PLANNING & ZONING COMMISSION

Wednesday, May 18, 2022, 10:00 AM

- B. **Request for Site Plan; Bristol Park Apartments** (Project Name); 19510 US 4541(Site Address) Limit Ave (South) US Hwy 441 (North East) (Location); Cagan Management Group, Inc. (Applicant); Wicks Engineering Services, Inc. (Engineer); L.R. Huffstetler, Inc. (Landscape Architect); Forum Architecture & Interior Design (Architect). Project No. SP22-03.

BRISTOL PARK APARTMENTS
 COVER SHEET
 MOUNT DORA, FLORIDA 34736

Wicks Engineering Services, Inc.
225 West Main Street, Tallahassee, Florida 32309
www.wicksengineering.com (904) 343-8667
CA #00662

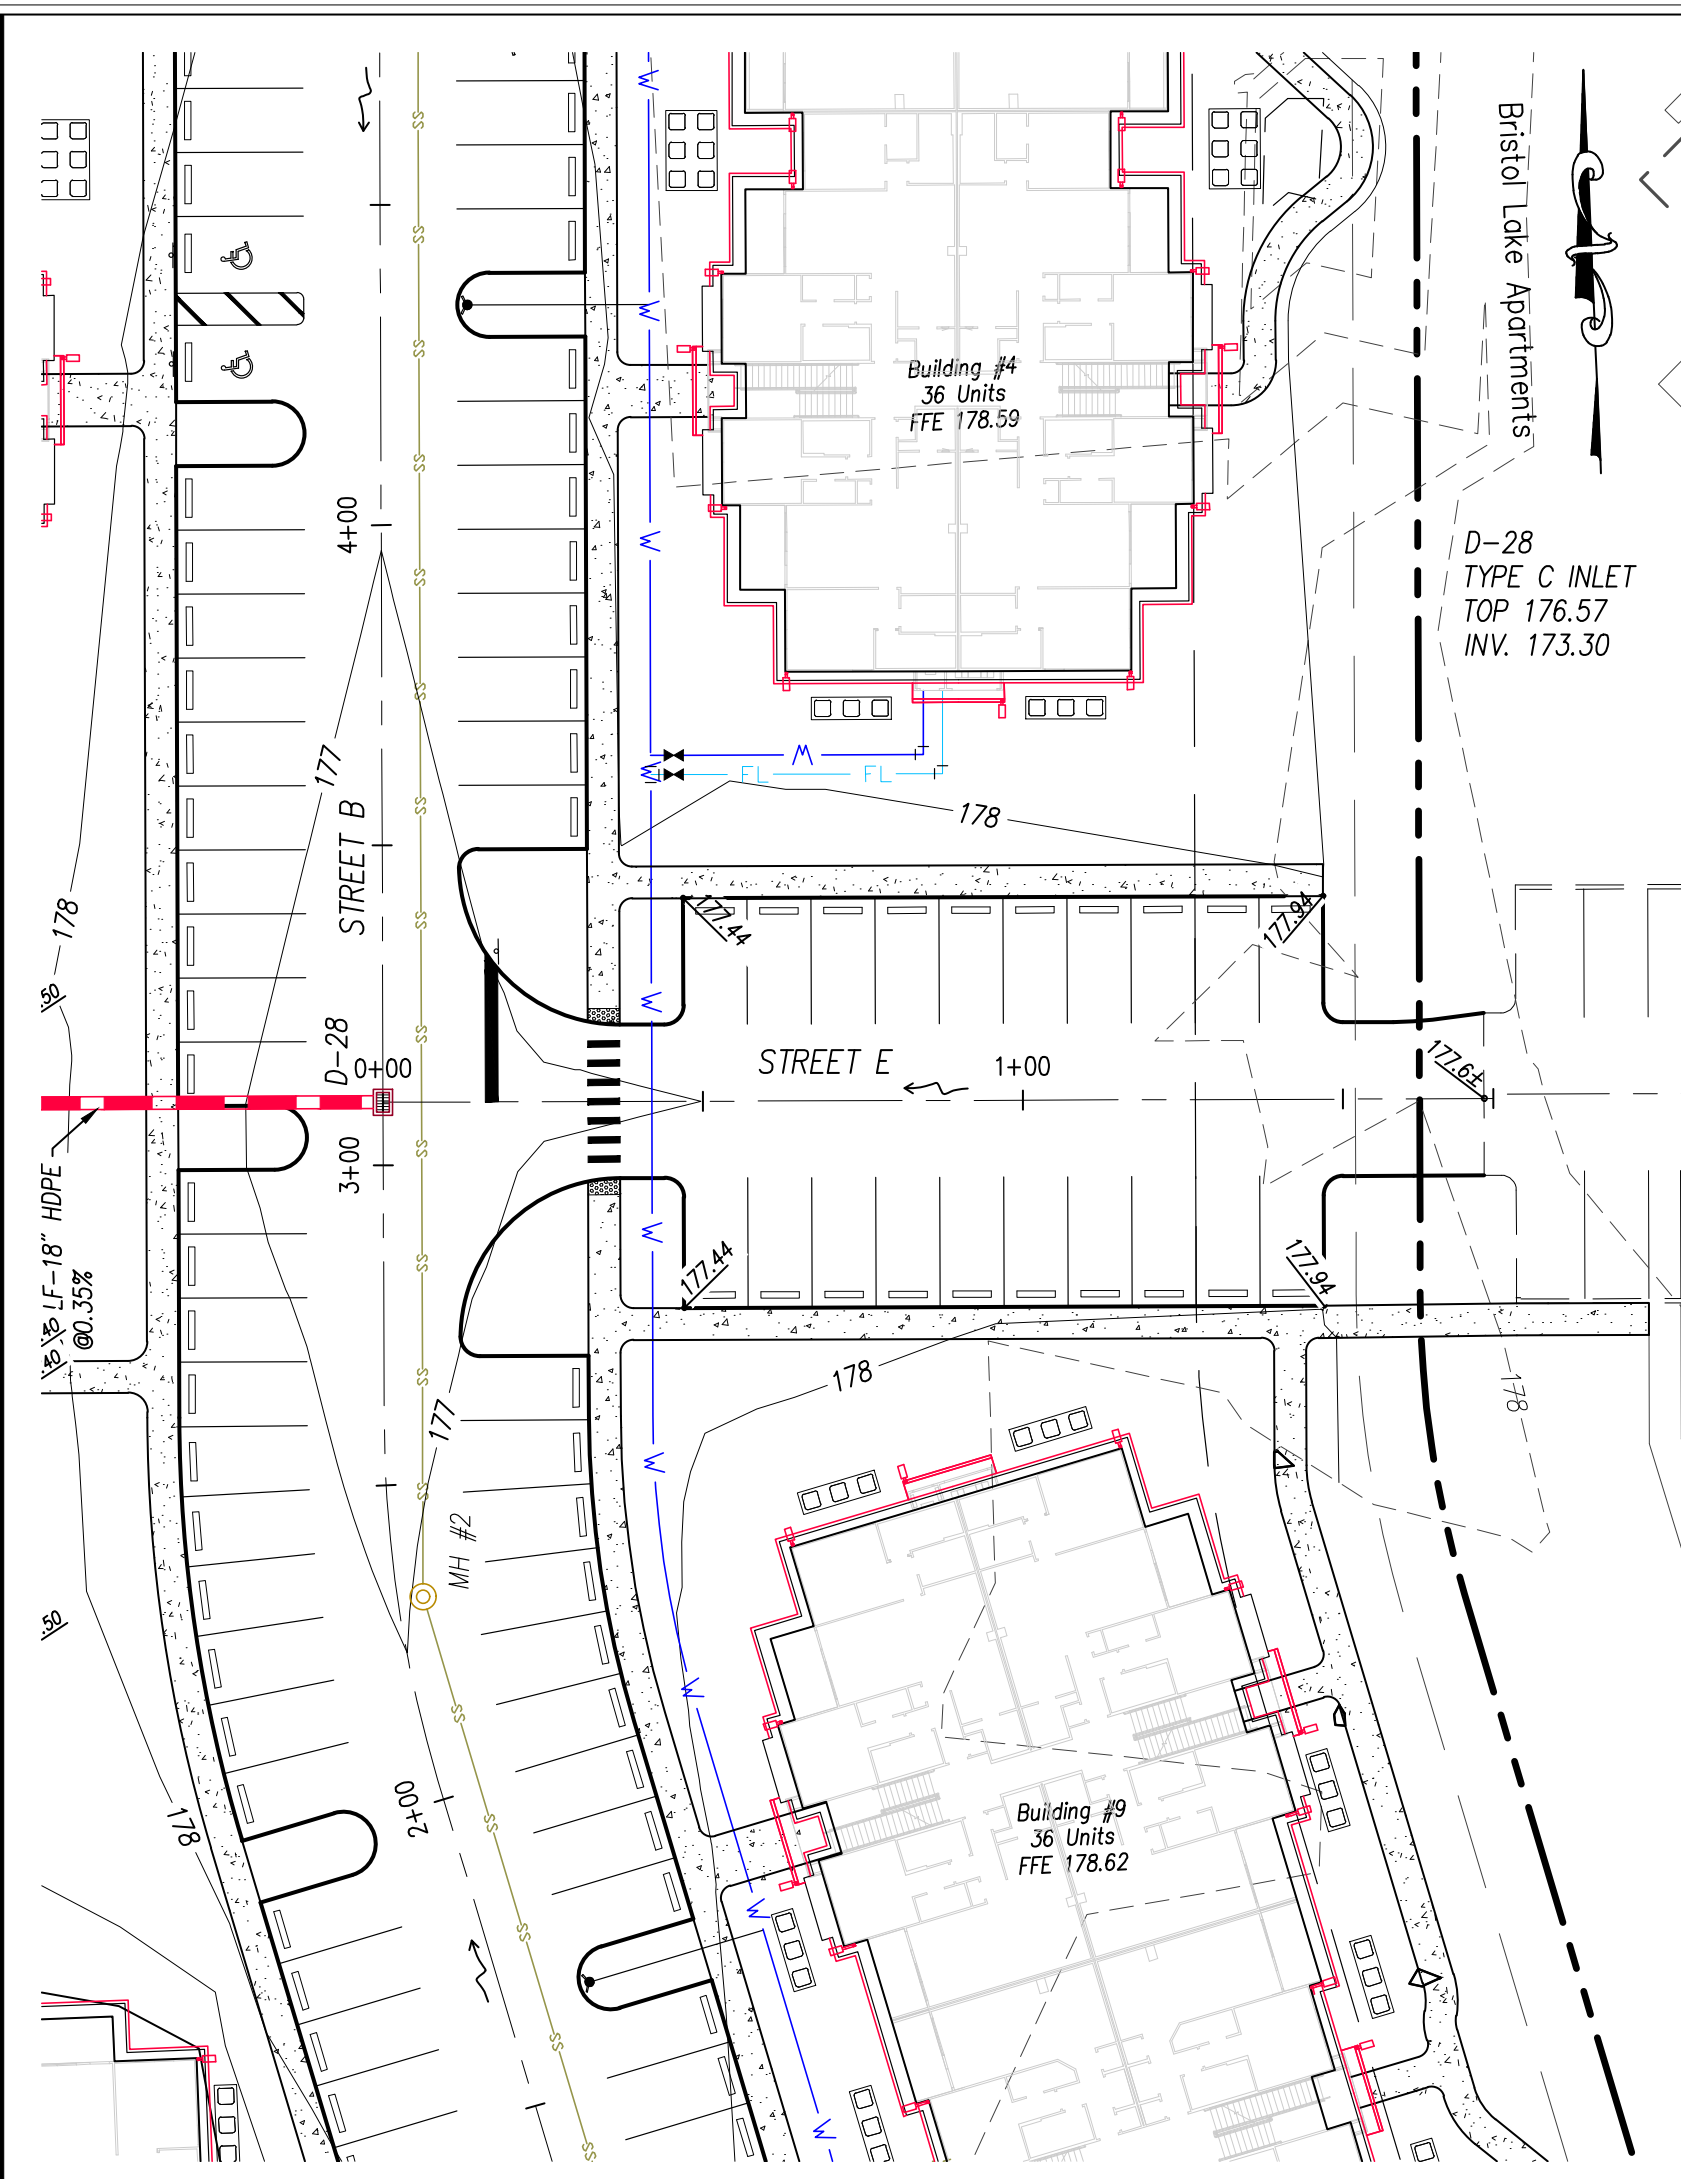
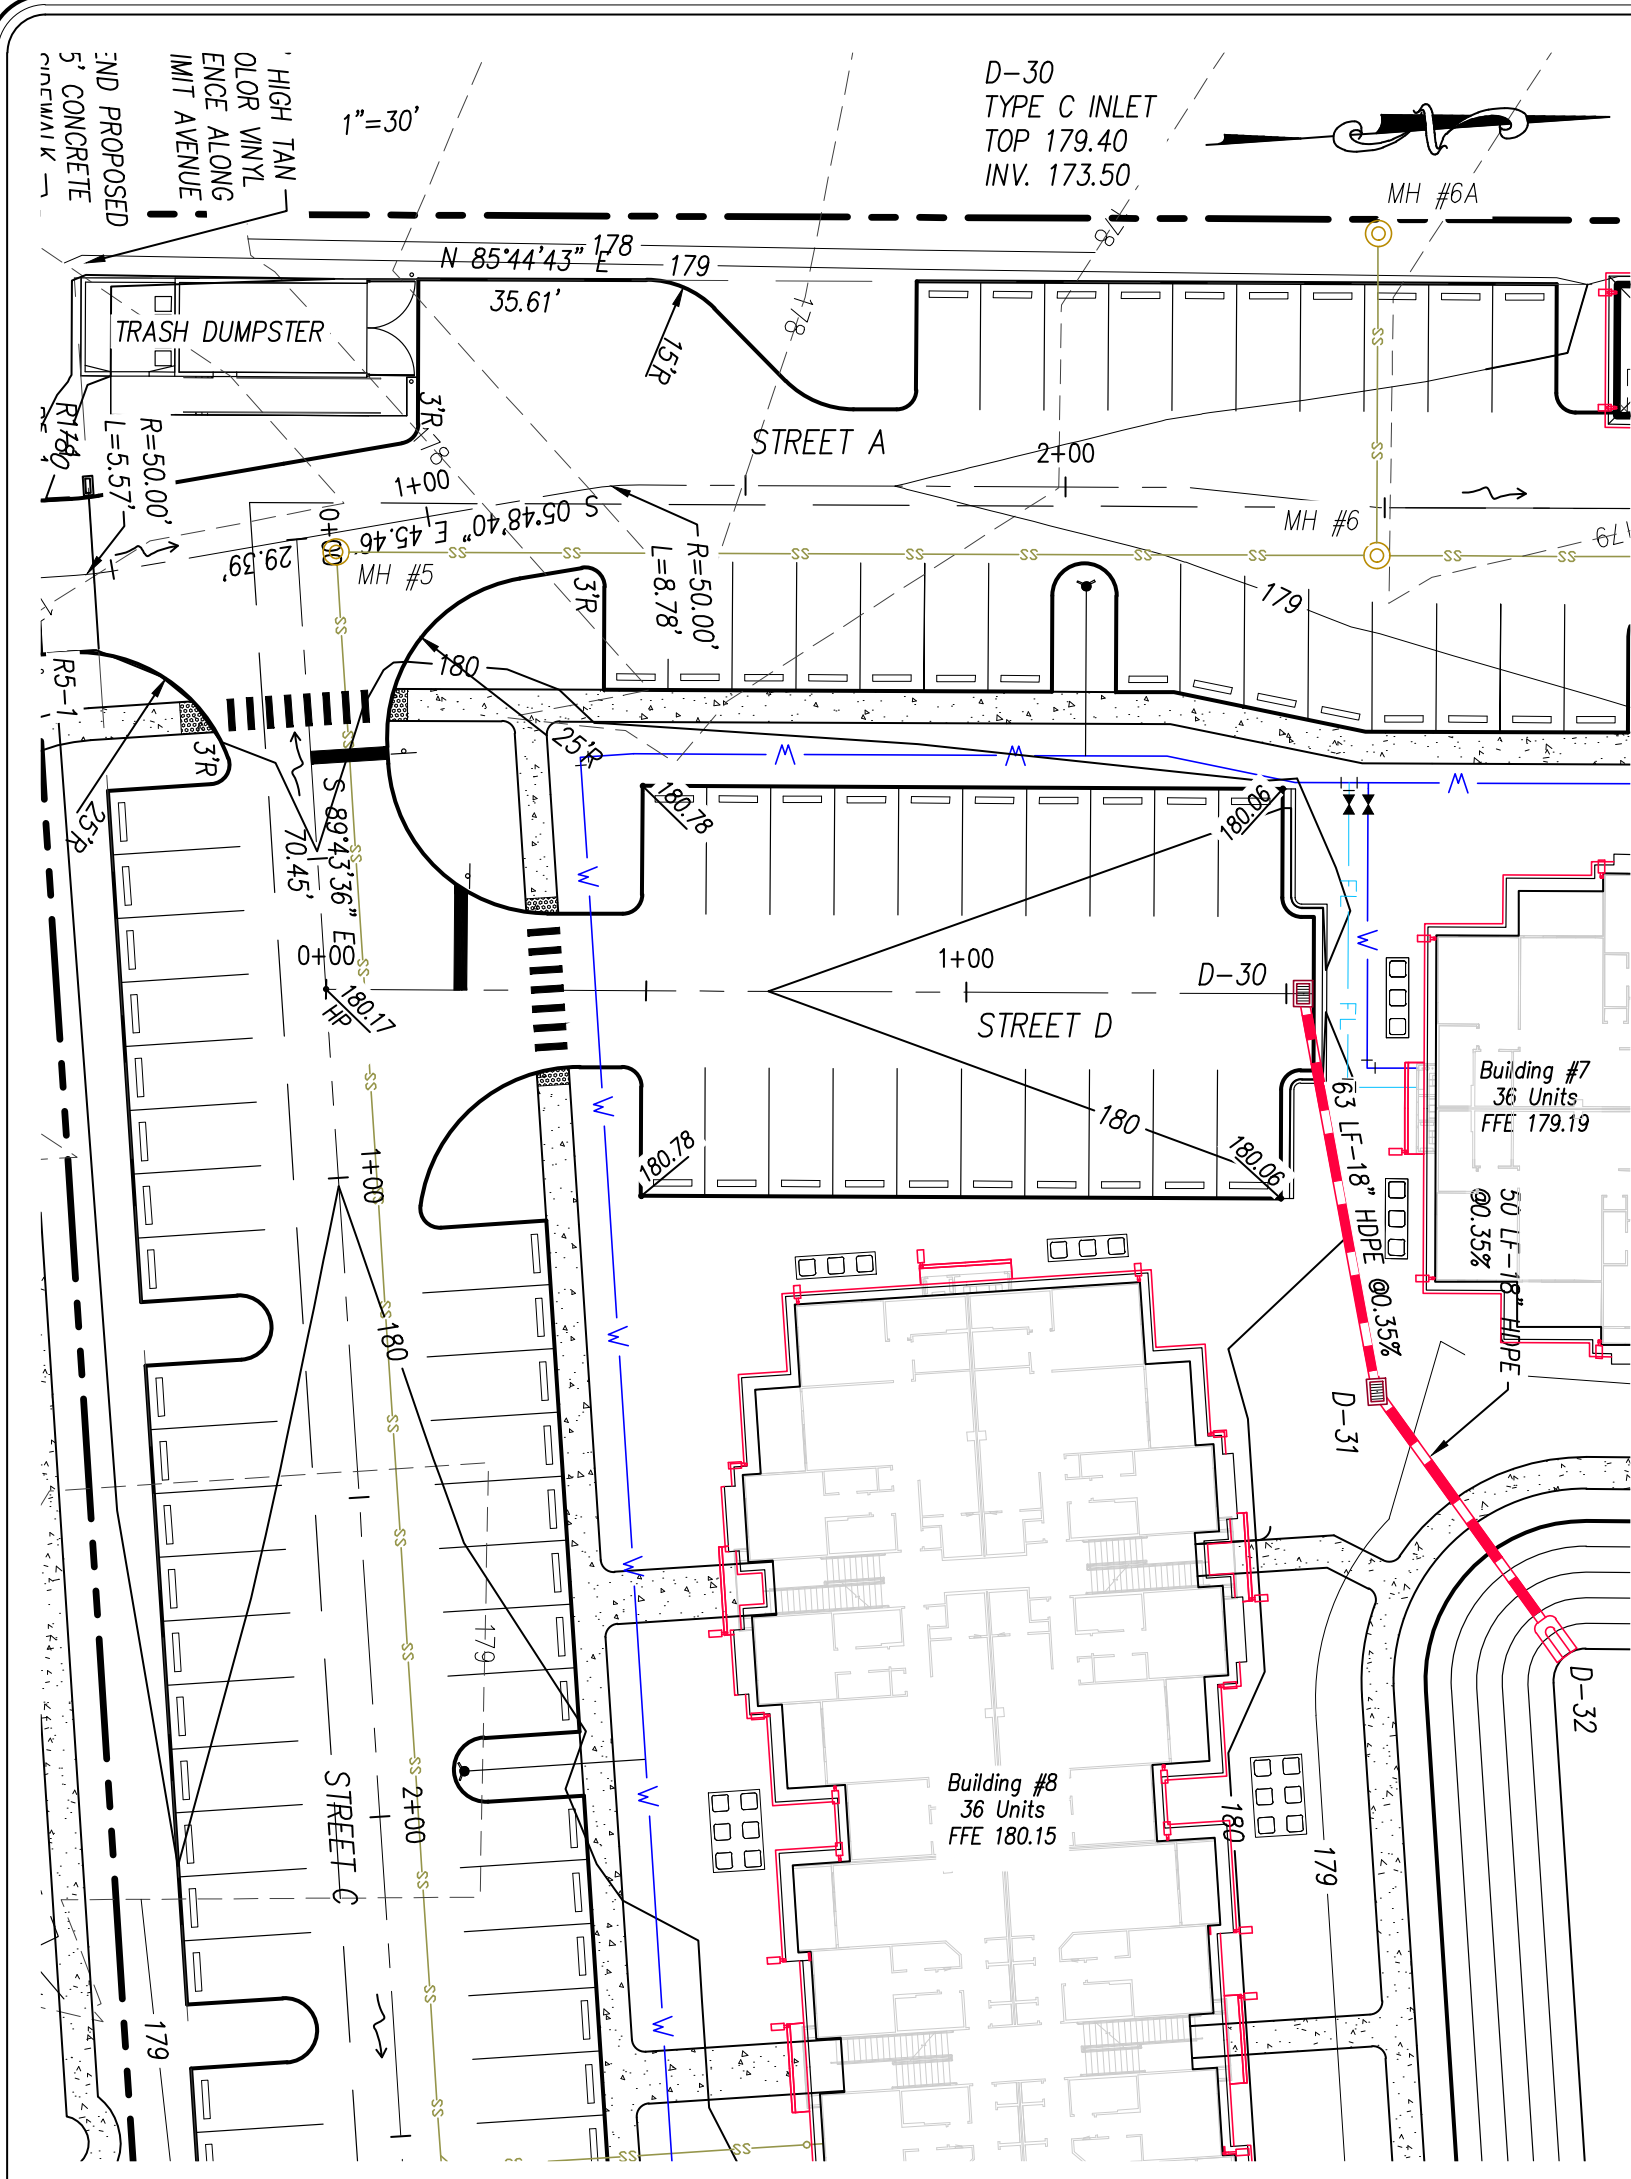
82. Sheet 15 of 32 – in the left hand profile view the water is shown to be at the same elevation as the sanitary sewer. Please correct with appropriate separation distances.

Drawn:	WSR	REVISION:	DATE:
Checked:	KRW	# COUNTY COMMENTS	03-18-22
Date:	03-04-22		
Scale:	AS SHOWN		
File No.:	19123		
Sheet: 20 of 32

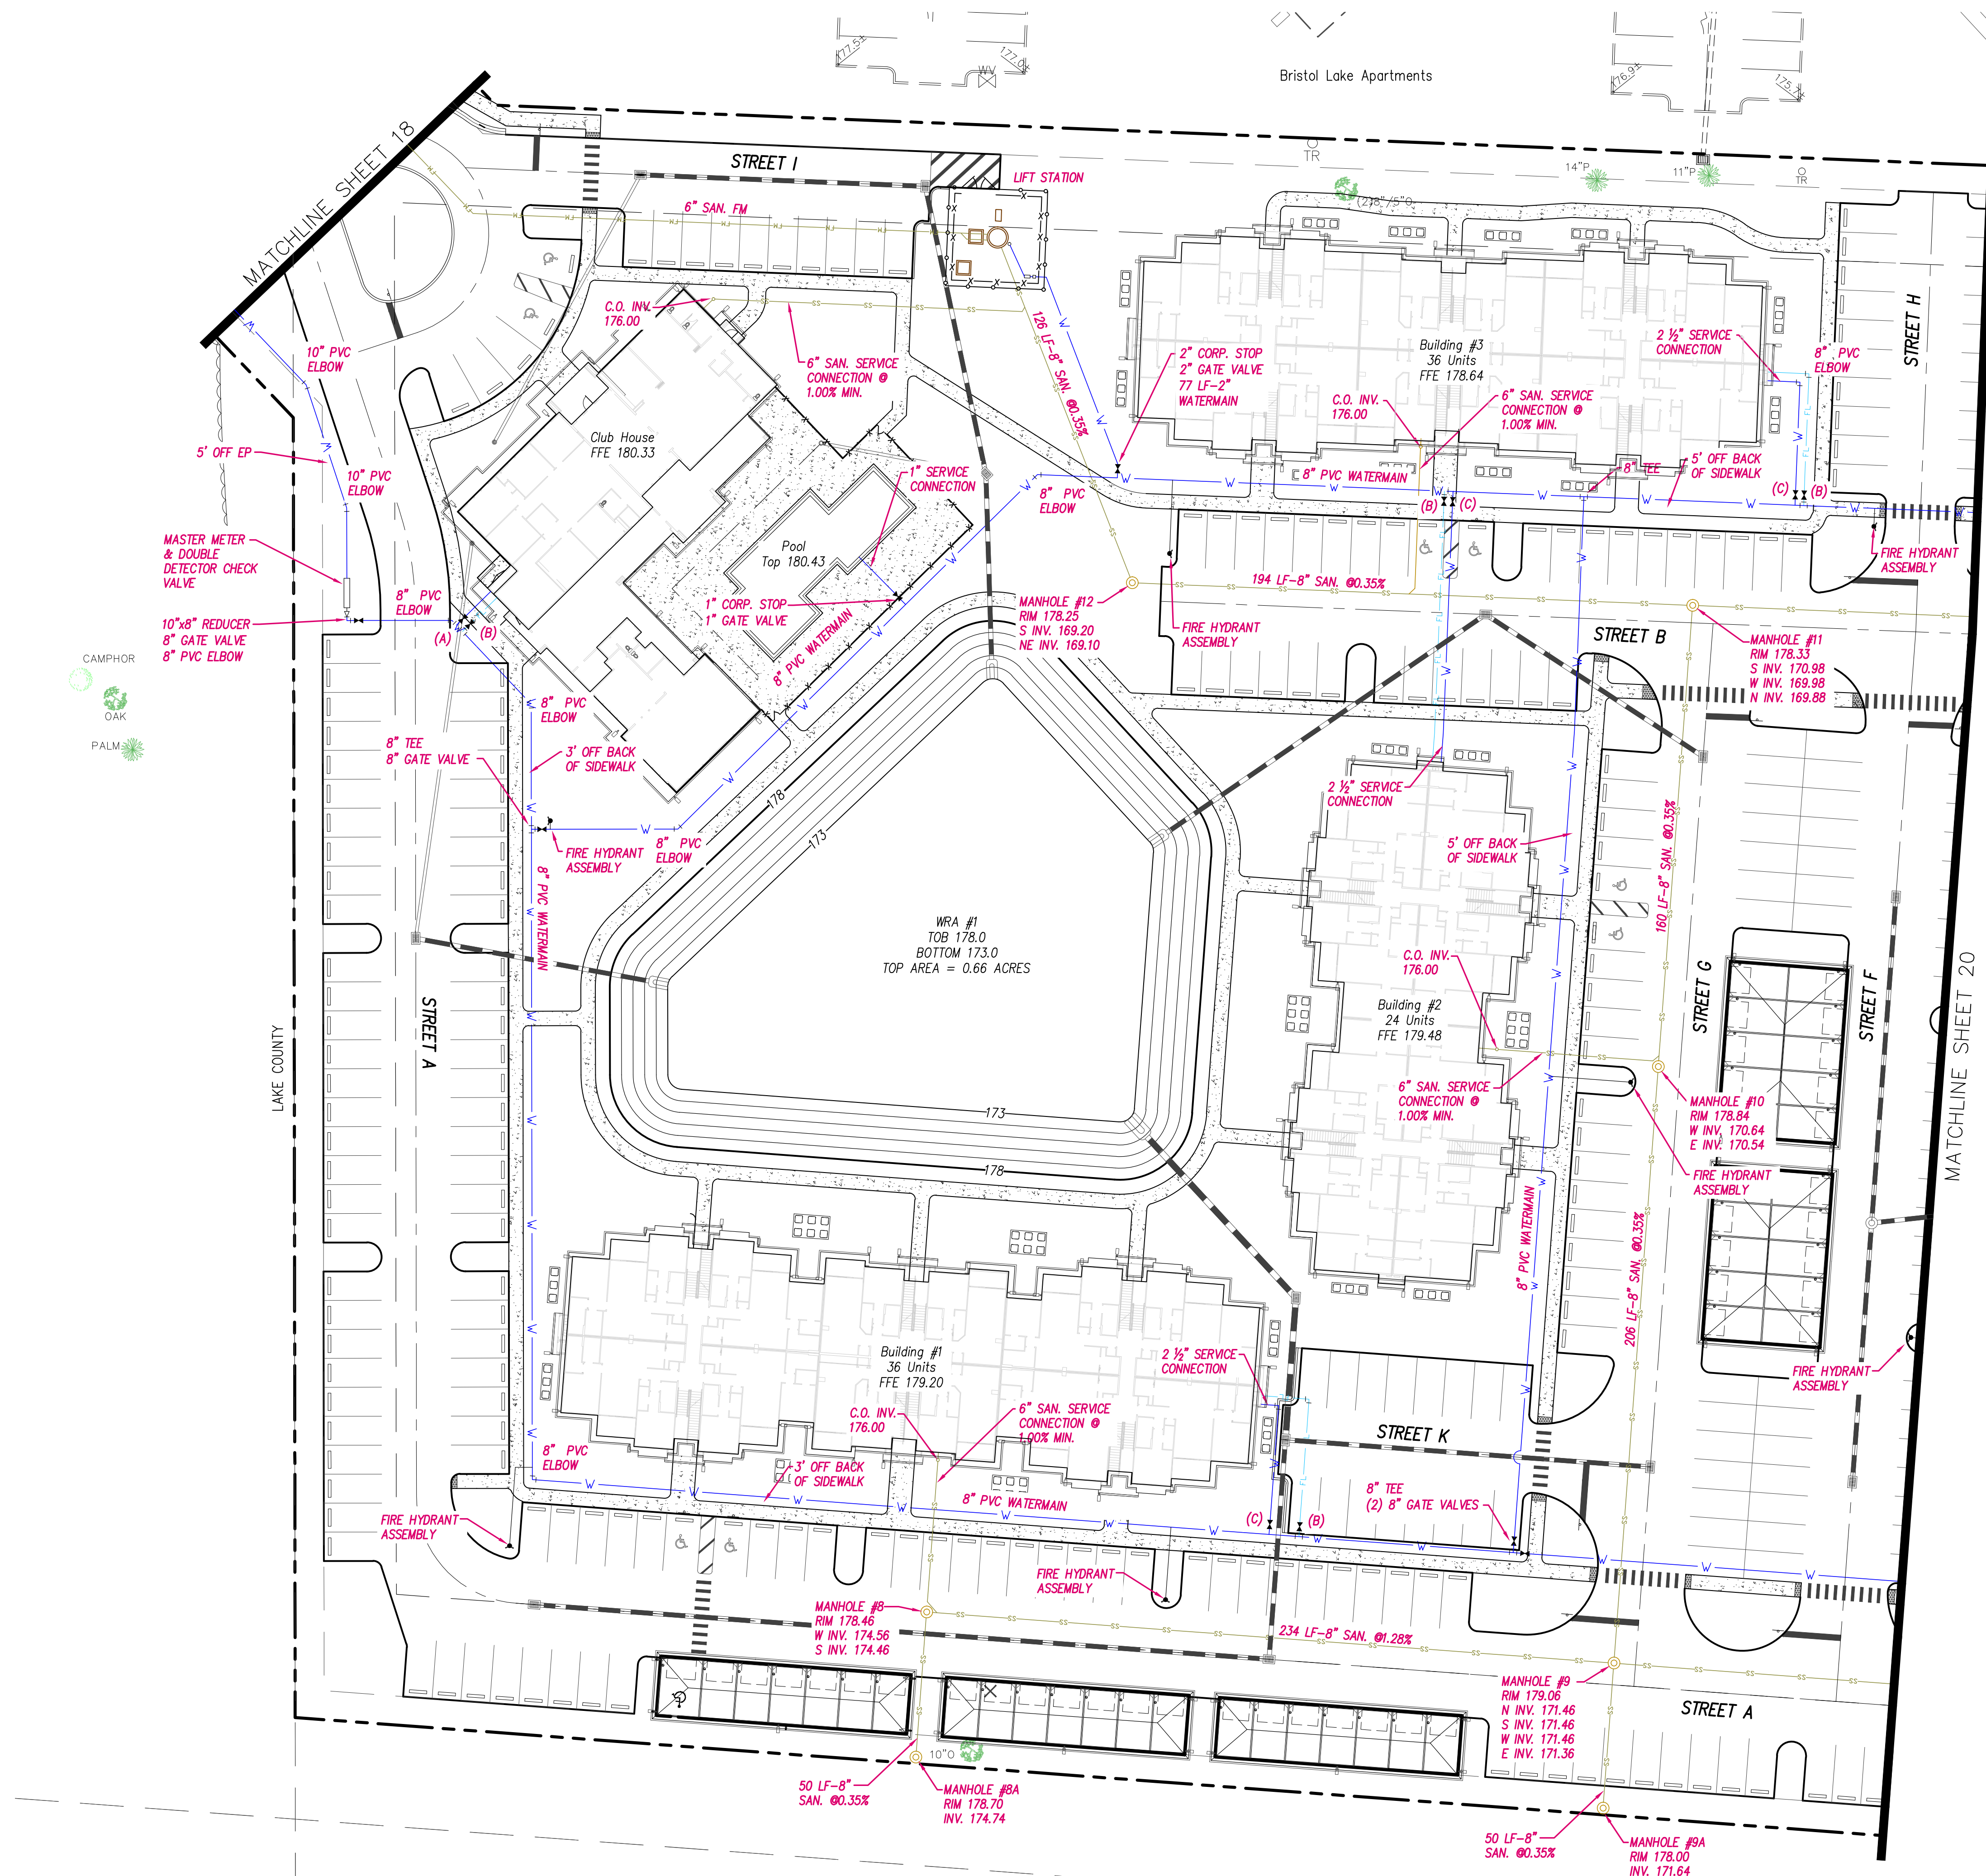
85. Sheet 20 of 32 – install a fire hydrant at approximately the connection of the entrance road to Bristol Park to the entrance road to Bristol Lake Roads.

37. Plan Sheet 20. There is a kink in the proposed force main crossing of Bristol Lakes Road. Provide an explanation / clarification on why this segment of line is not straight.

40. Plan Sheet 20. If the lift station is to be private, provide a secondary valve vault at the property line with a check and plug valve prior to the FM point of connection. This valve vault will prevent FM back flowing and allow CoMD access for connection shut-down.
